Change Order #6 Dicker Road

Project: Dicker Road
Project #: STP 1902 (383) MM
Contract: C-19-017-11-05
CSJ: 0921-02-312
Limits: Spur 115 (23rd Street) to FM 2061 (Jackson Road)

Change Order #6 includes two pavement re-evaluations performed by TEDSI to modify the final pavement and the temporary detour pavement design. It includes plan and quantity modifications for missing items and quantity adjustment for errors within the plans. It also includes an item to modify the Item 341 asphalt bonus and penalties.

**EXISTING AND PROPOSED
TYPICAL SECTIONS**

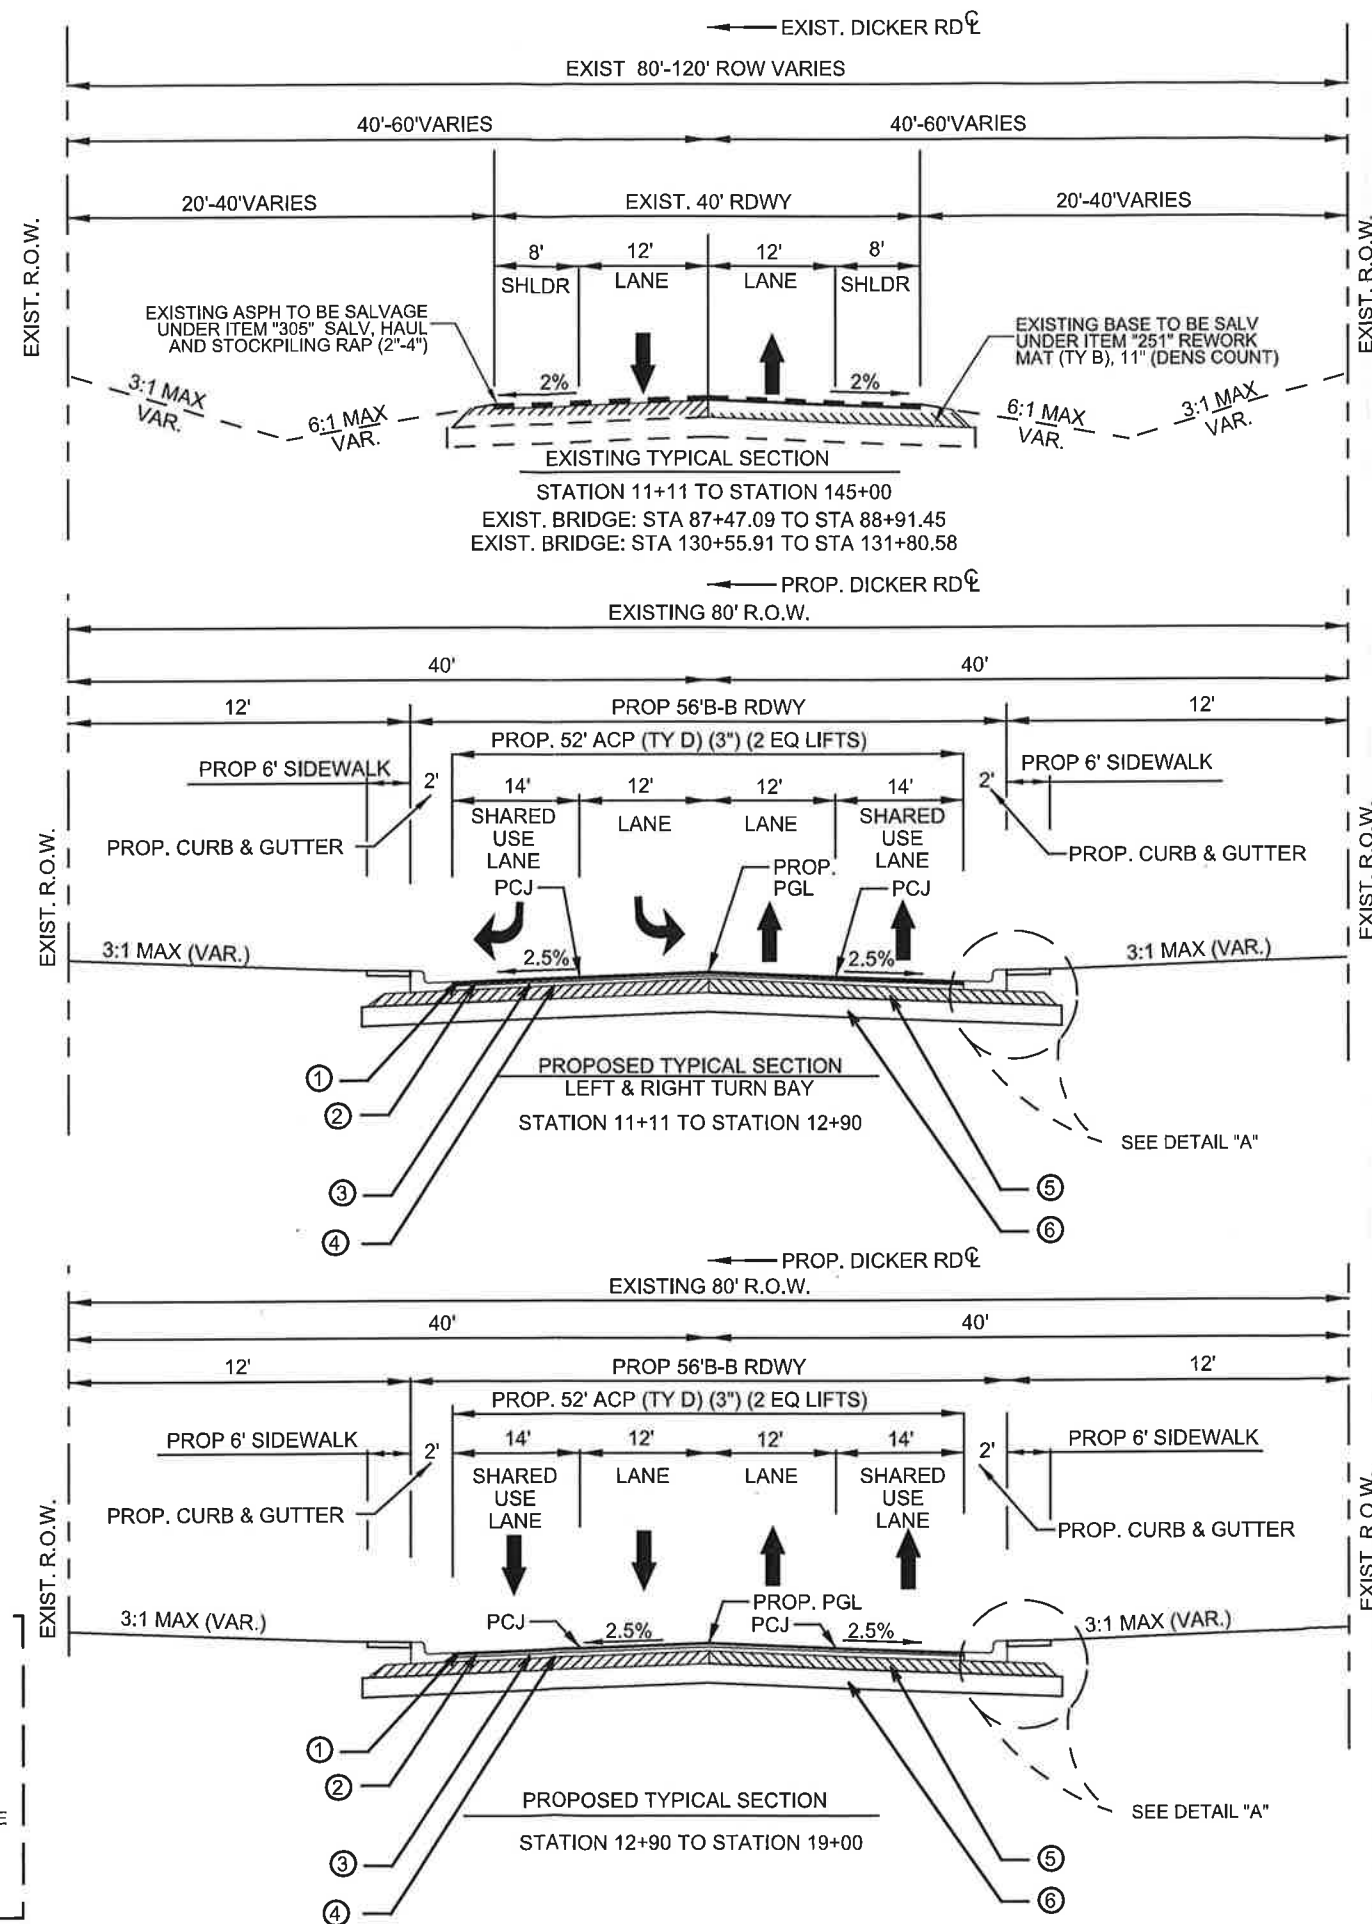
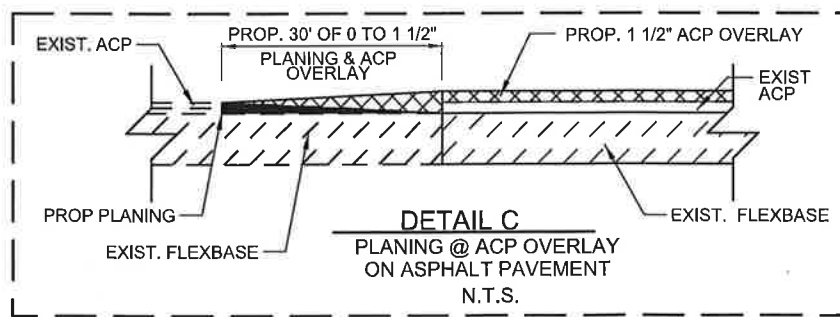
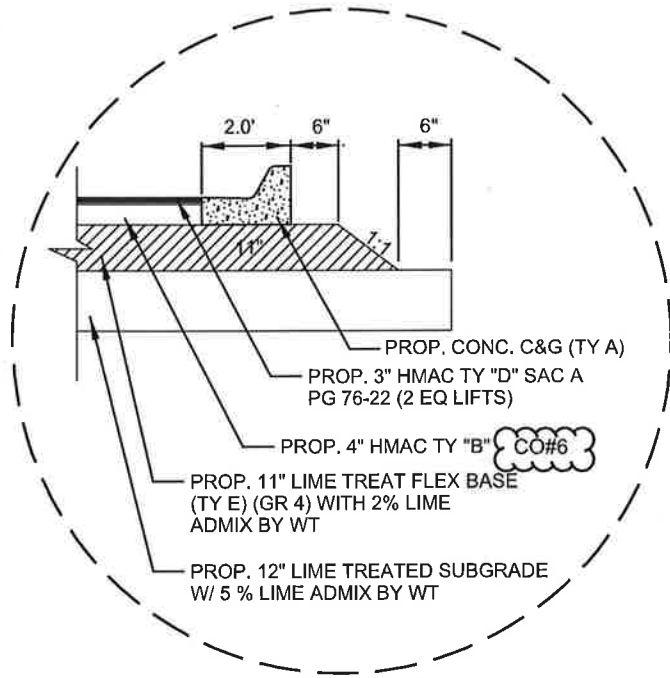
**CO#6 - PERMANENT PAVEMENT
MODIFY TY "B" HMAC TO 4" AND LTFB TO 11"**

Hidalgo County Precinct #2 requested that TEDSI reanalyze the design for a possible valued engineering opportunity, to determine if the asphalt thickness was oversized. TEDSI, the Engineer of Record, verified that 4" of Ty "B" asphalt will manage the same loading and life expectancy requirement as the 4 ½" of asphalt. CO #6 will remove 2,227 tons of Ty "B" asphalt, reducing the plan quantity to 21,875 tons. See Attachment A for details.

DICKER ROAD
PROPOSED TYPICAL SECTIONS

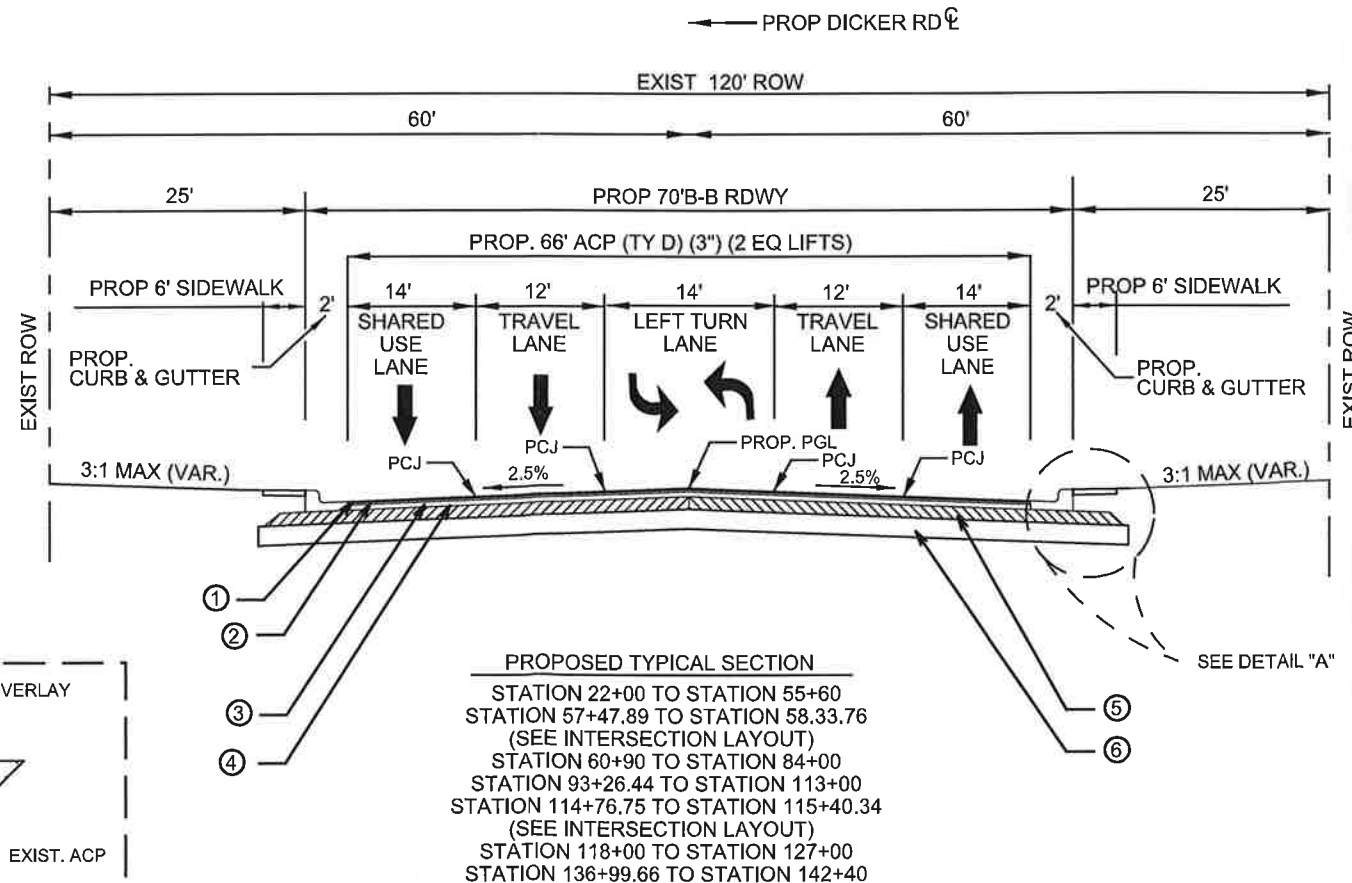
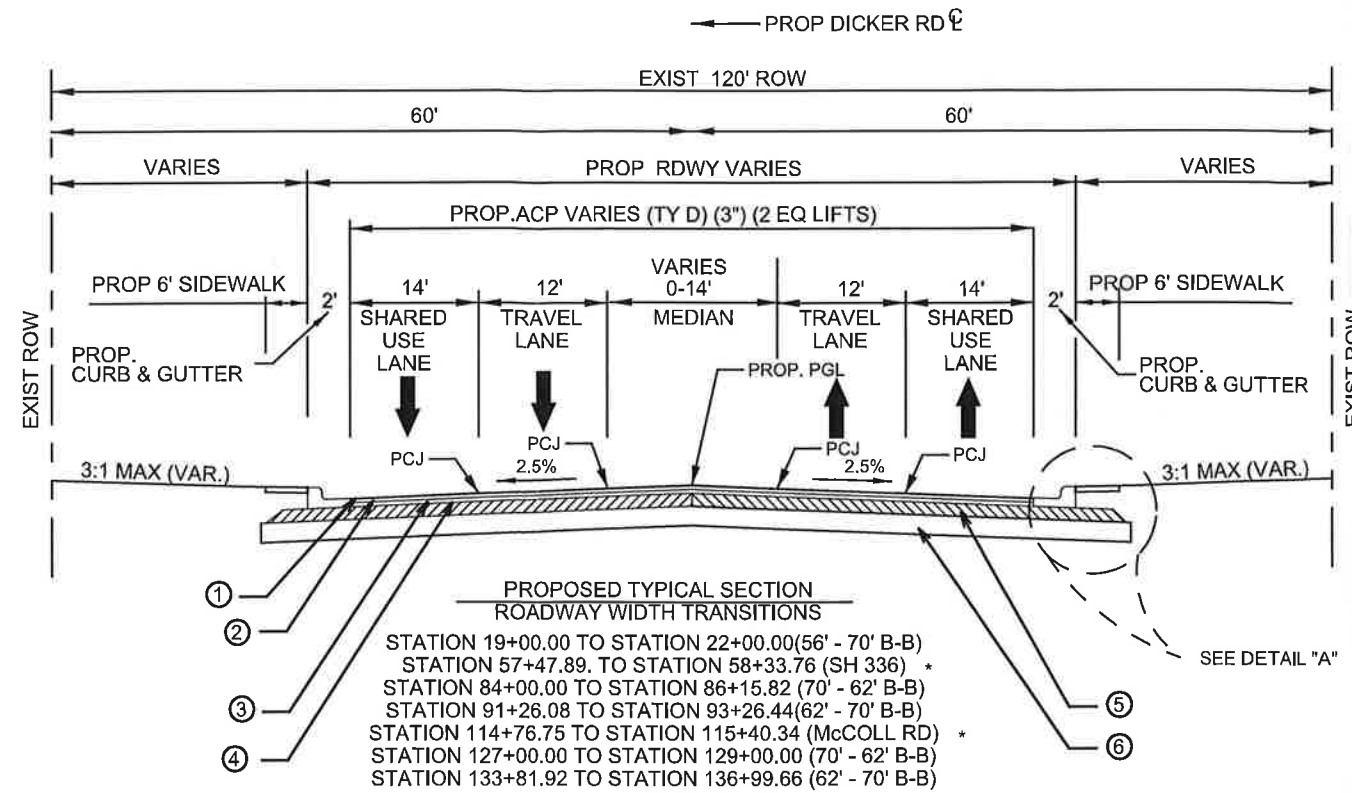
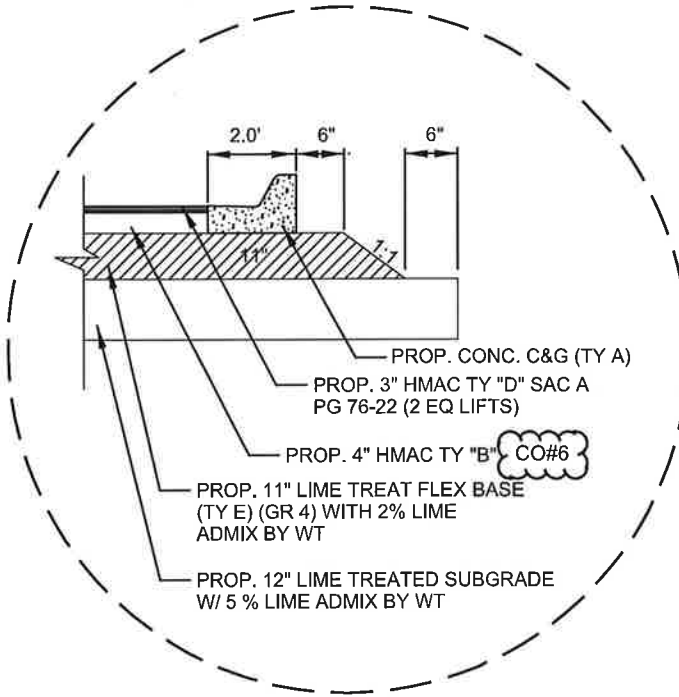
CO#6 - PERMANENT PAVEMENT
MODIFY TY "B" HMAC TO 4" AND LTFB TO 11"

DICKER ROAD
 PROPOSED
 TYPICAL SECTIONS

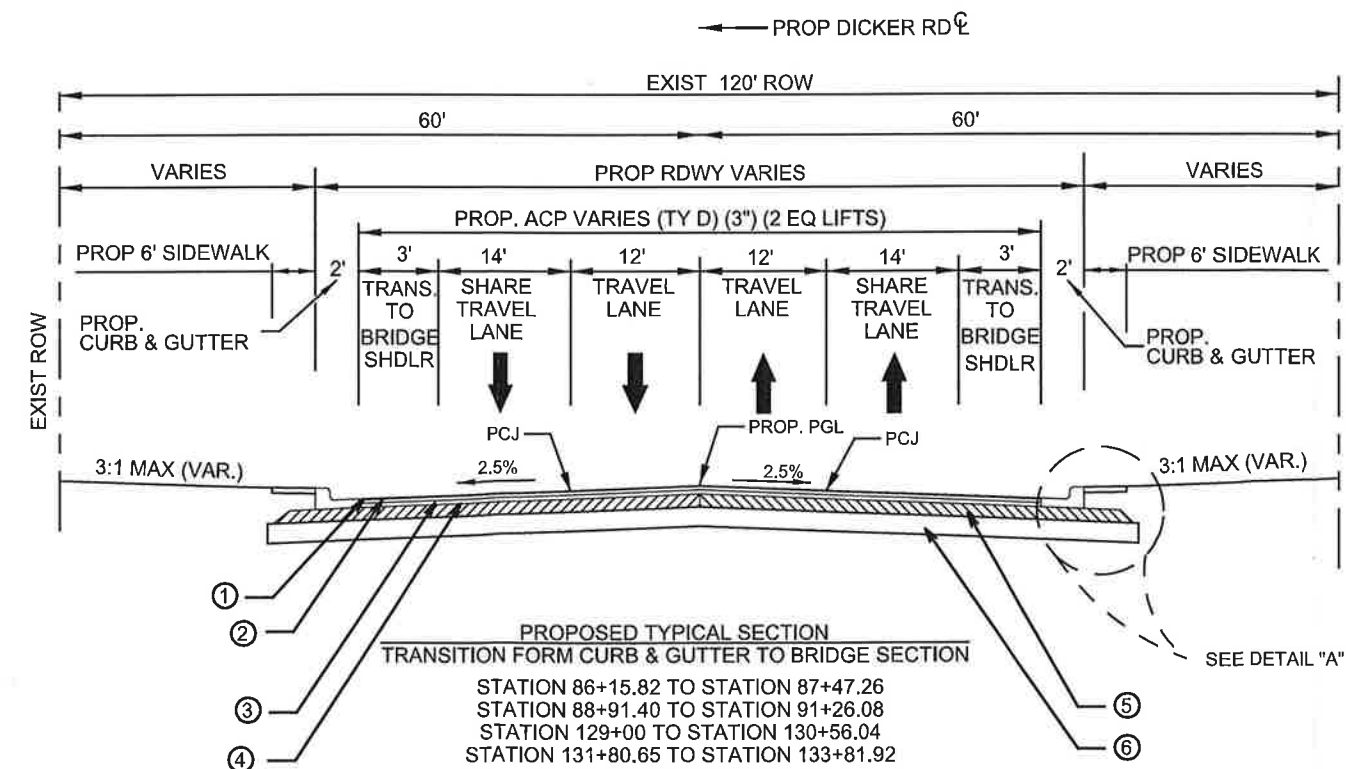
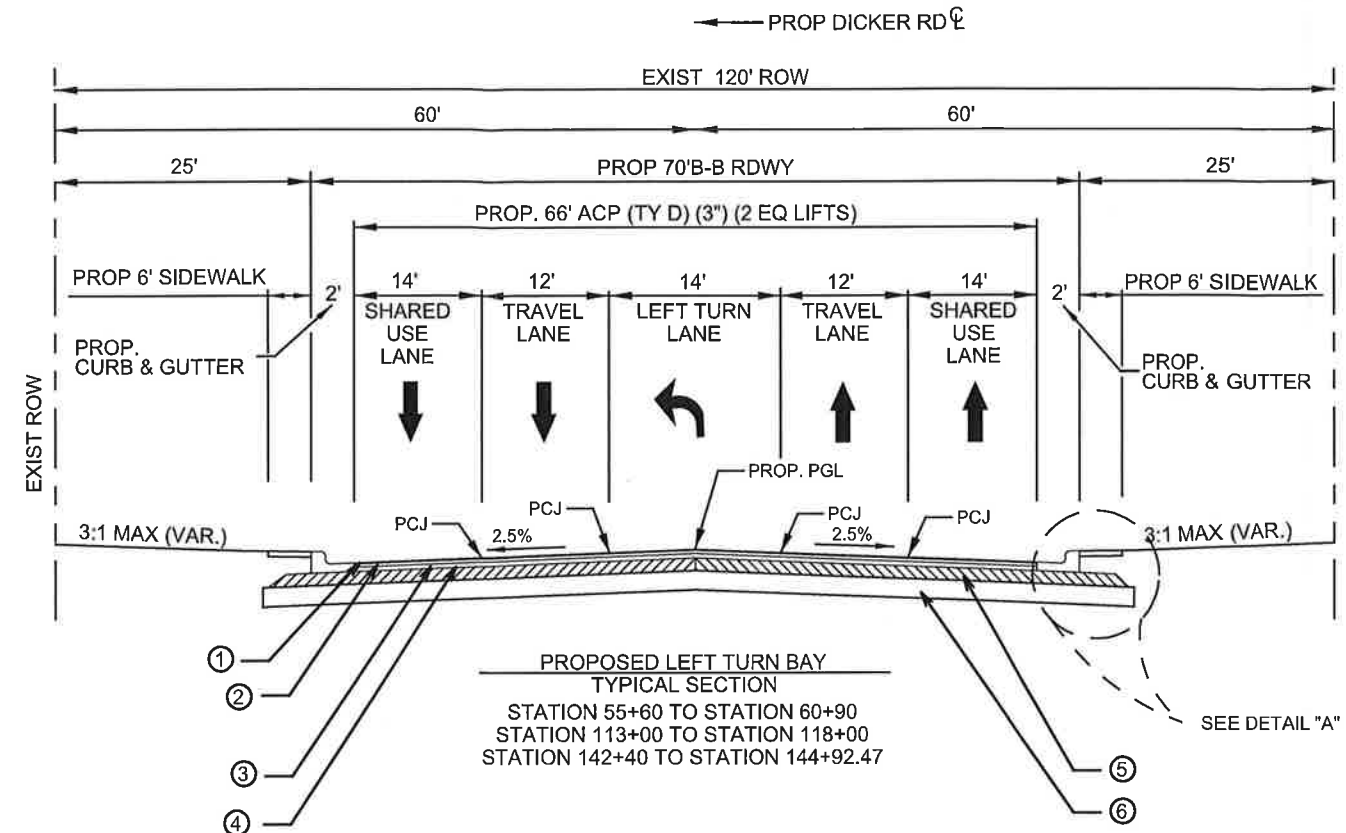
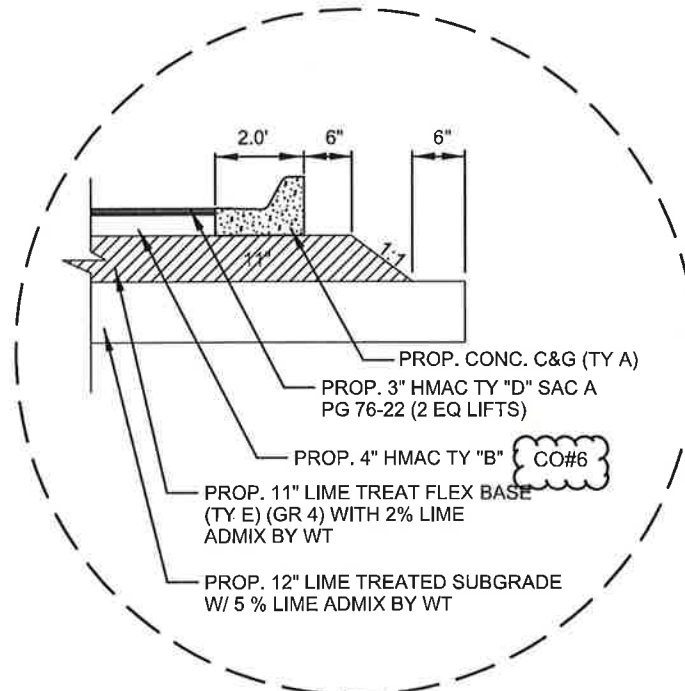
CO#6 - PERMANENT PAVEMENT
 MODIFY TY "B" HMAC TO 4" AND LTFB TO 11"
